ADDENDUM NO. 1

PROJECT TITLE: Parker Park Community Center Pool Addition
City of Jonesboro
Jonesboro, Arkansas

COMMISSION NUMBER: 2301

DATE OF ISSUE: August 18, 2023

C004

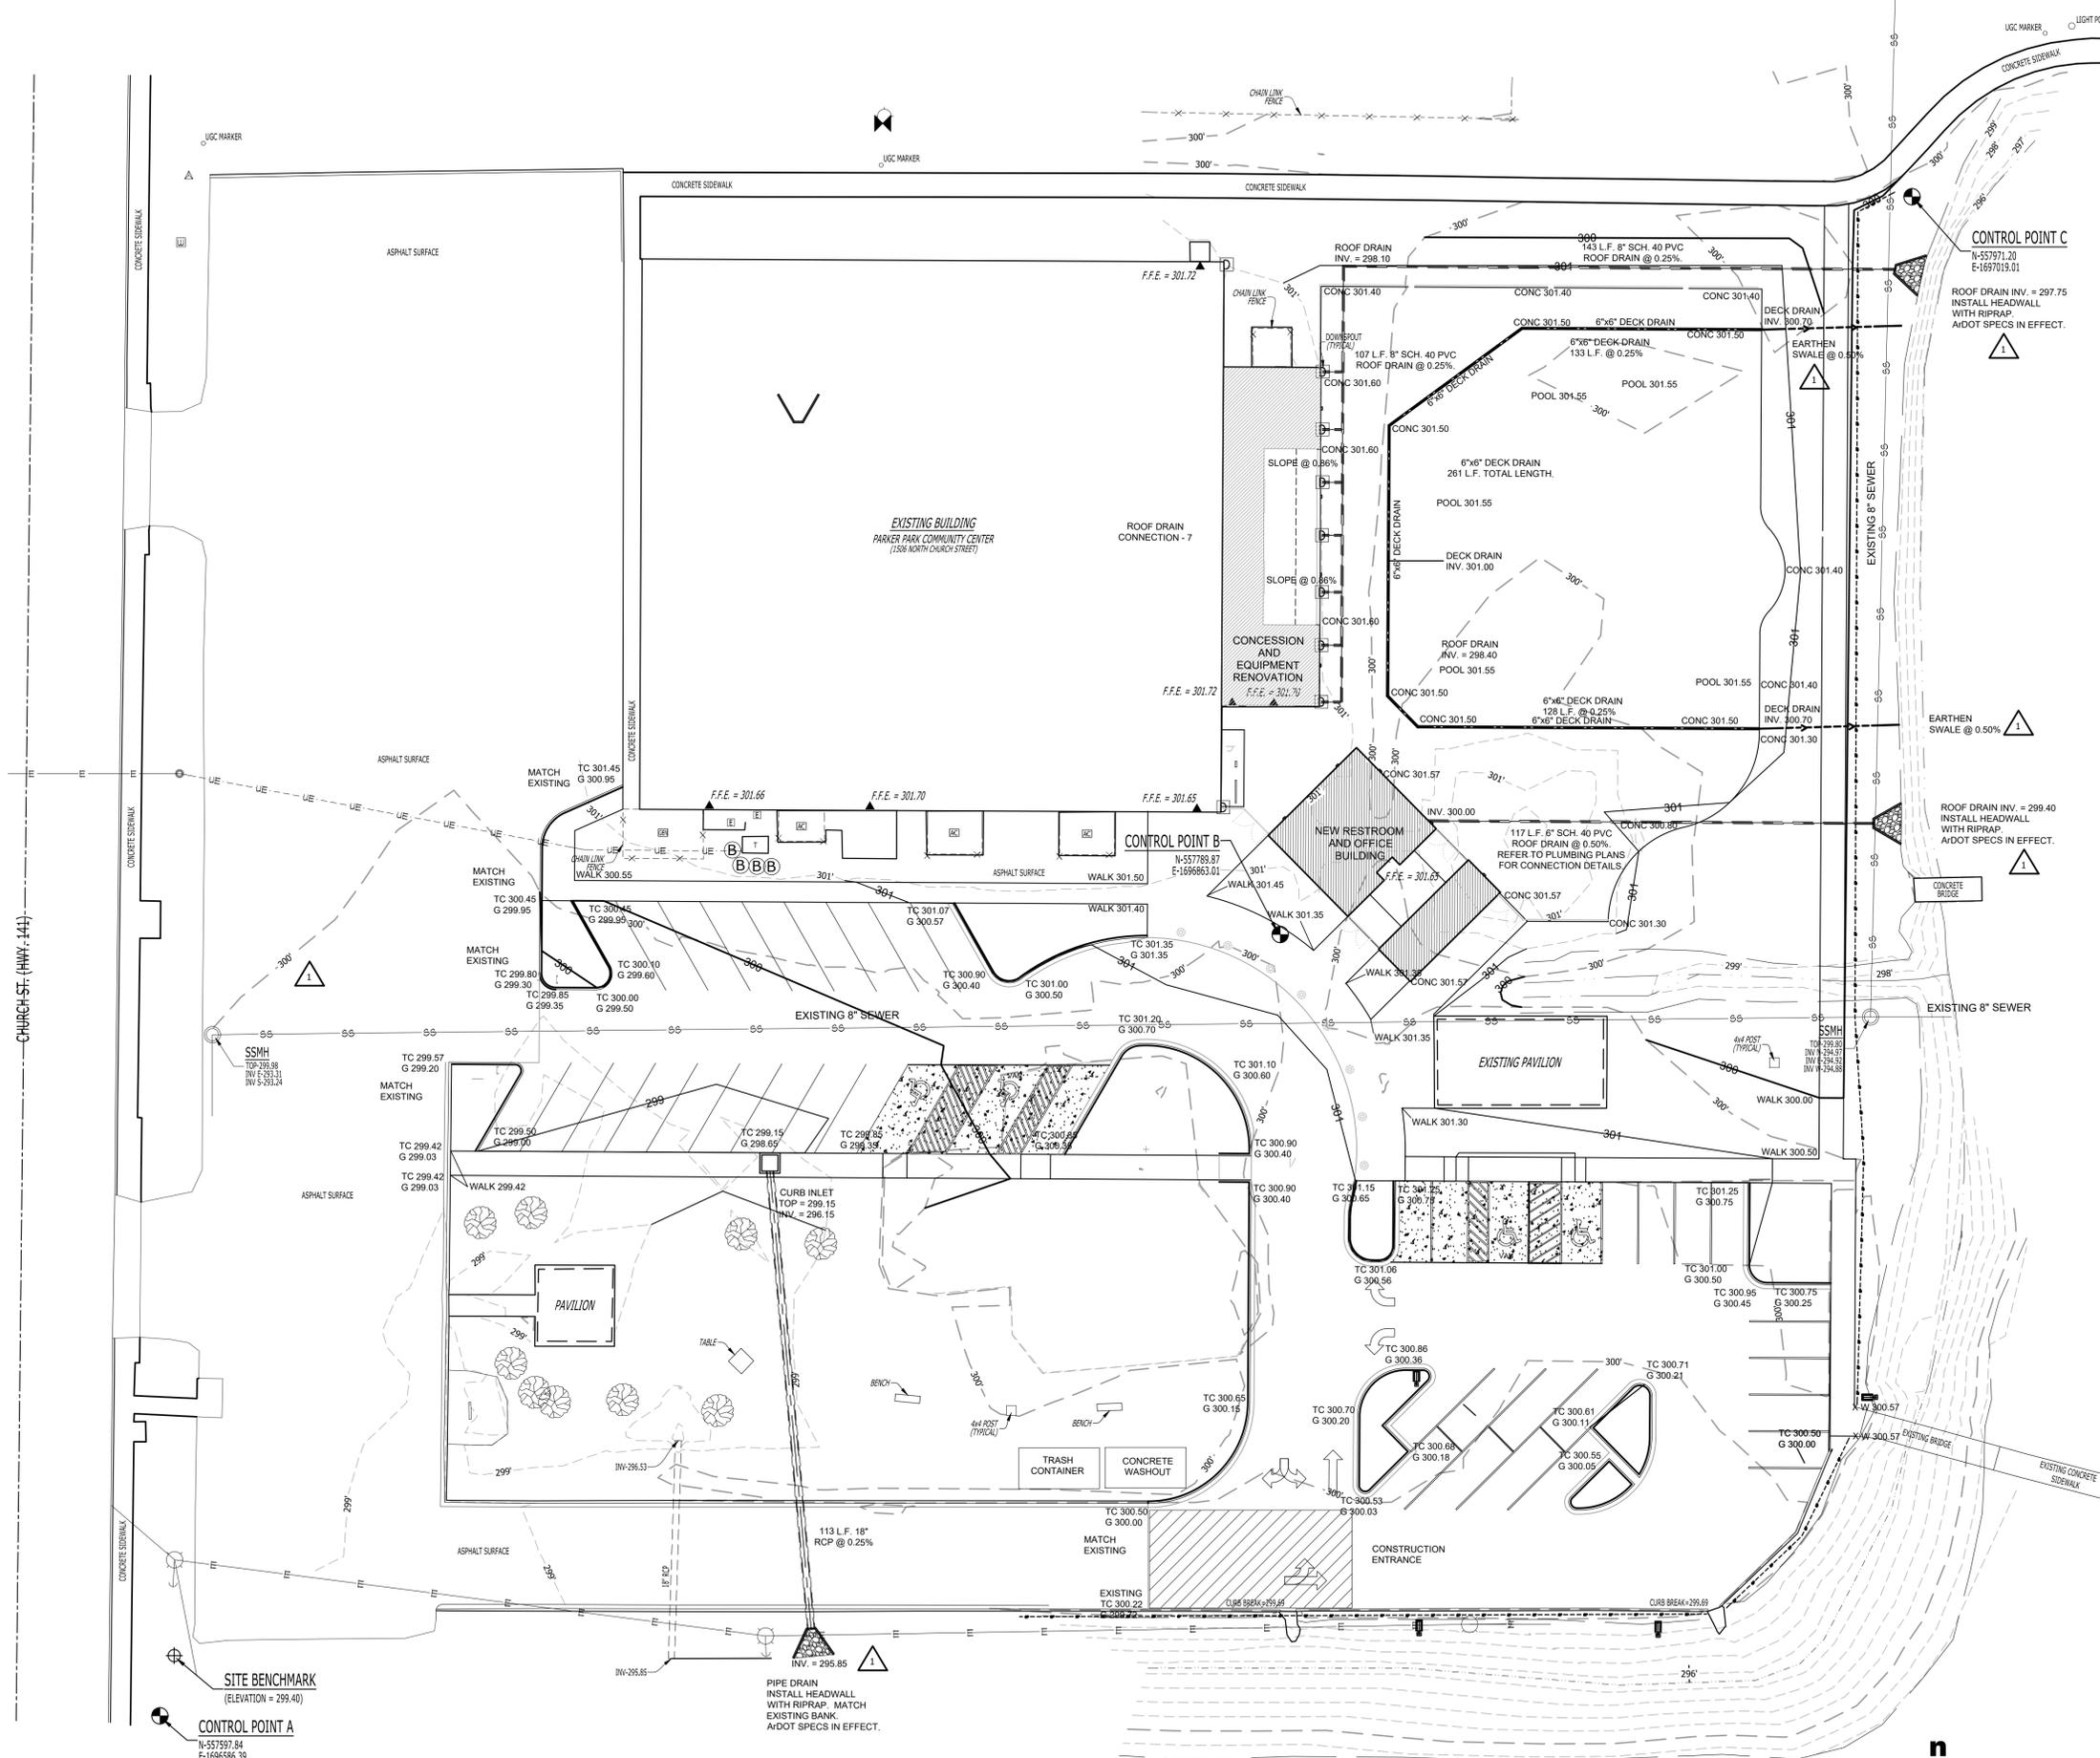
4. Drawings: Sheet C004- Site Utility Plan

- A. Omit Sheet C004 in its entirety. Replace with attached Sheet C004 dated 08.18.23.
Refer to page 12 of this addendum.
- a. Site utilities (sewer and water) have been clarified.

Commission Number
 2304
C005
 Date: August 4, 2023

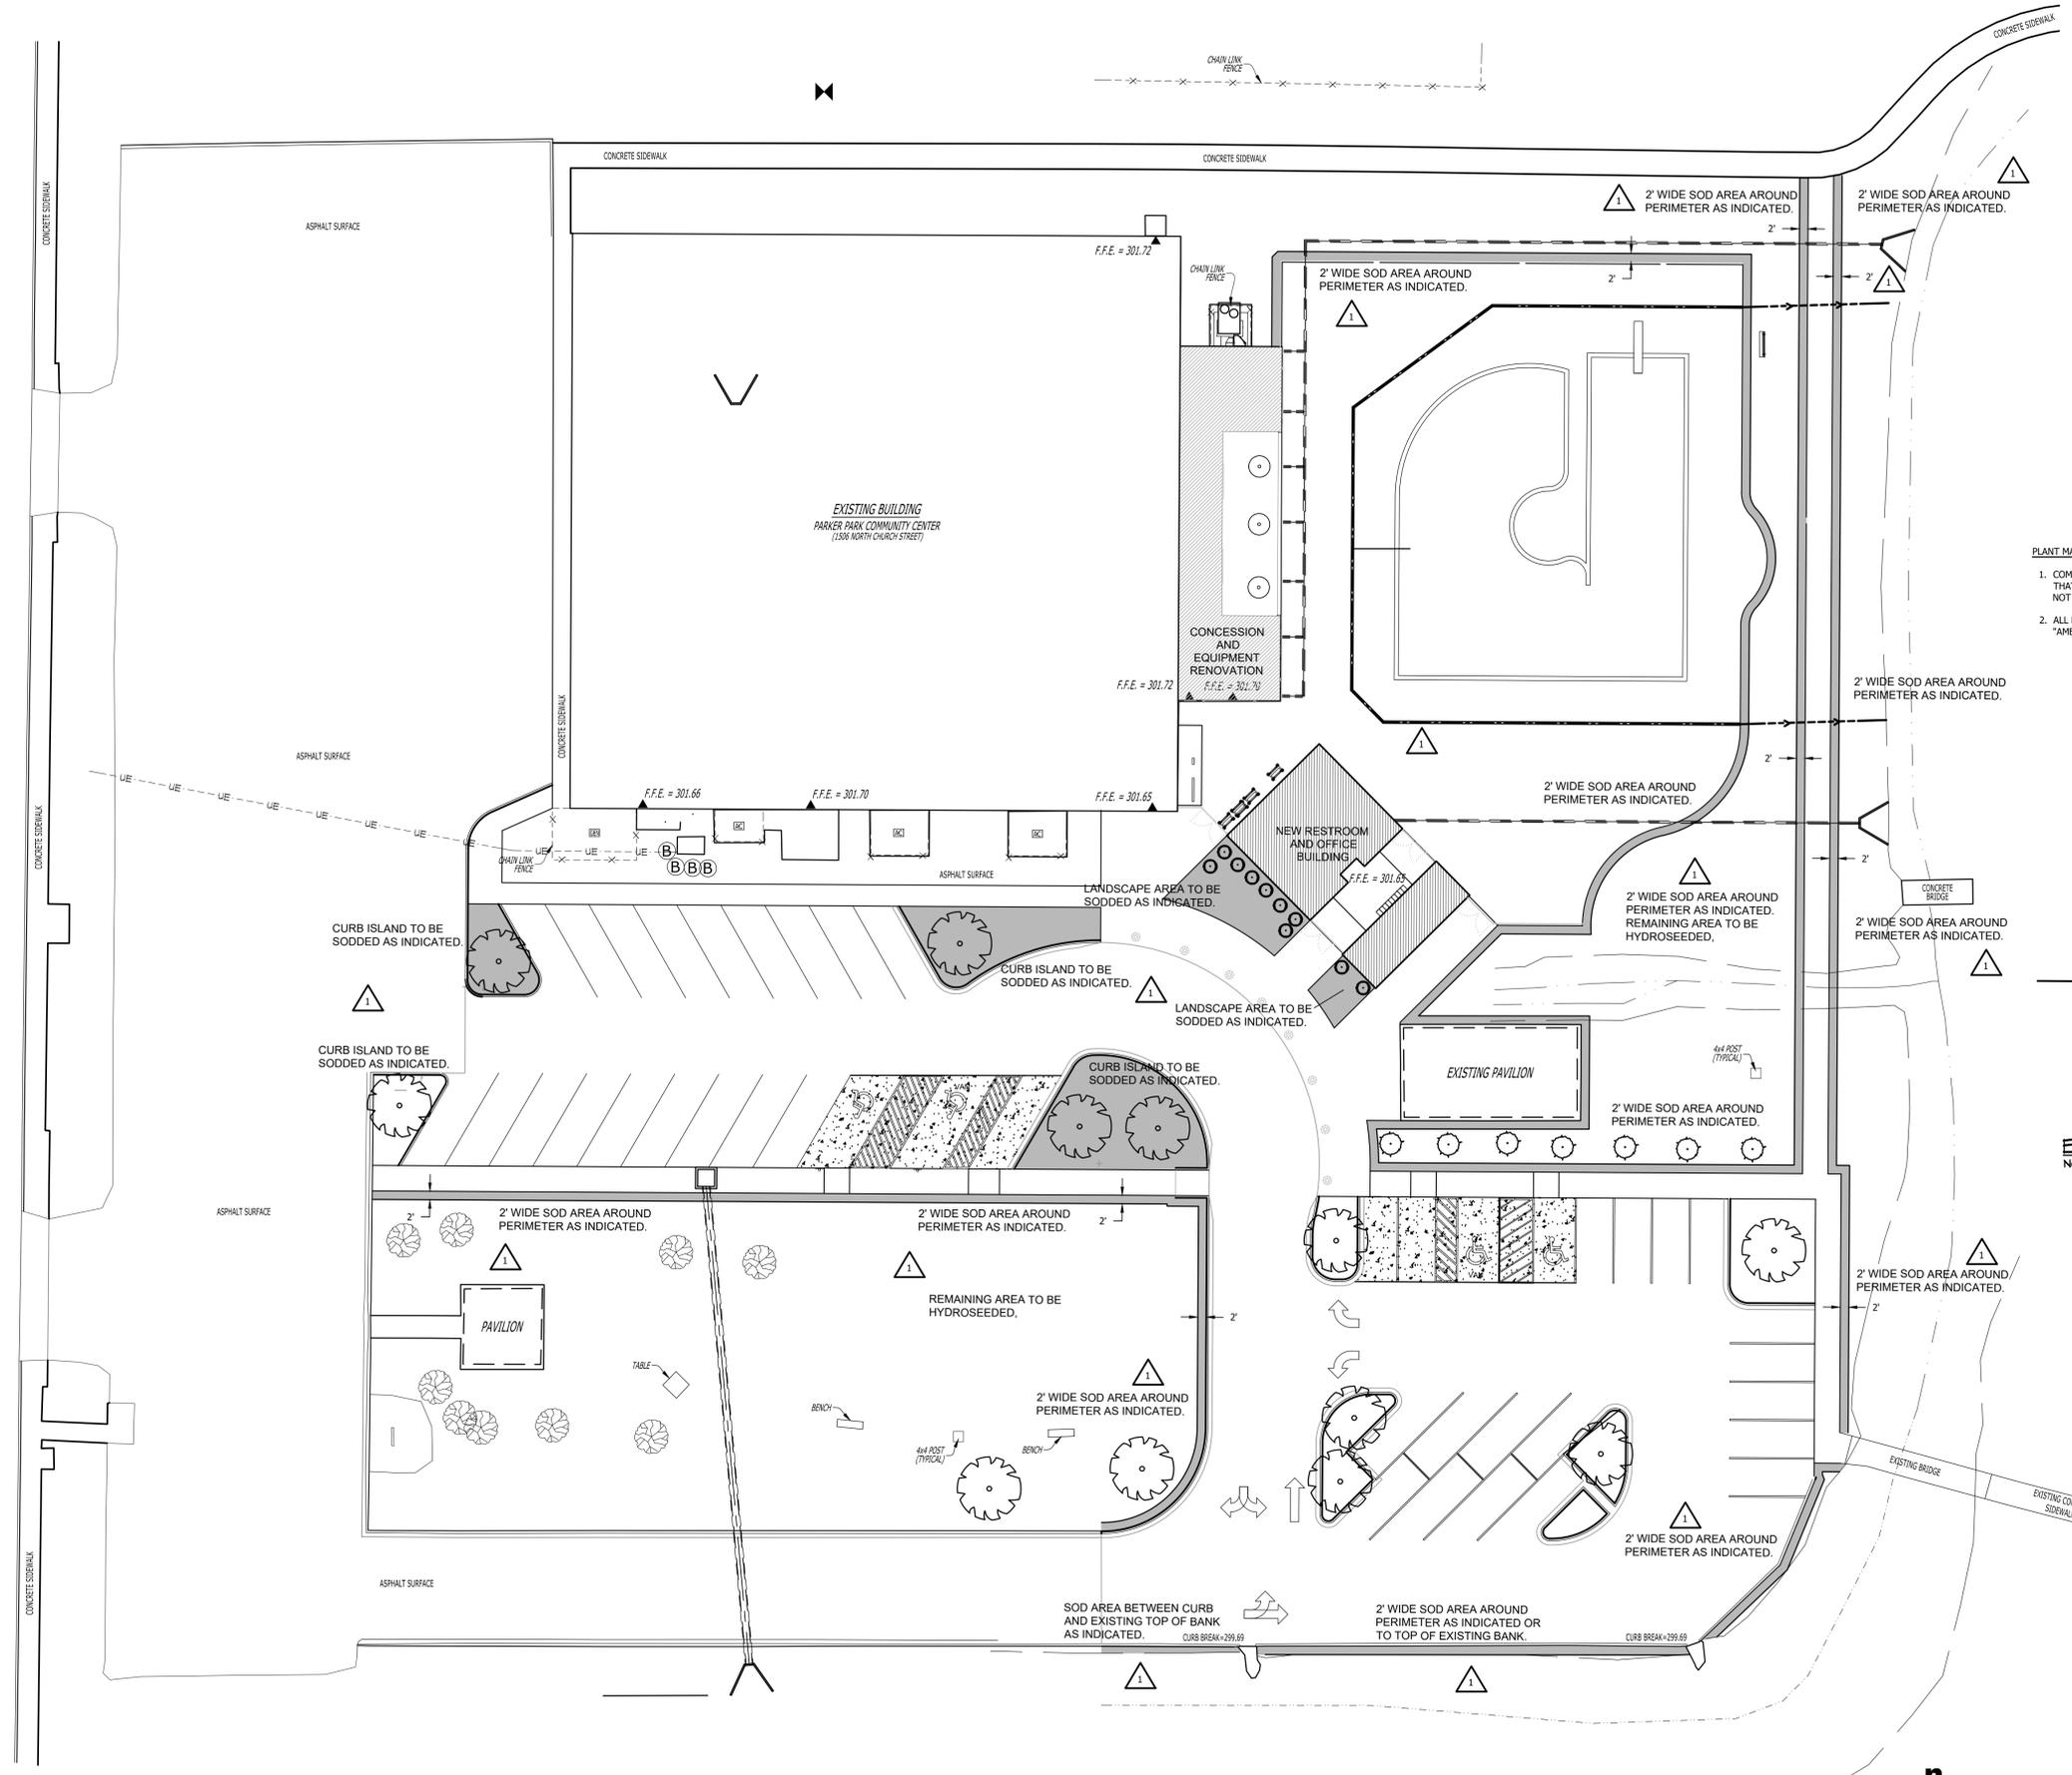
5. Drawings: Sheet C005- Grading and Erosion Plan

- A. Omit Sheet C005 in its entirety. Replace with attached Sheet C005 dated 08.18.23.
Refer to page 13 of this addendum.
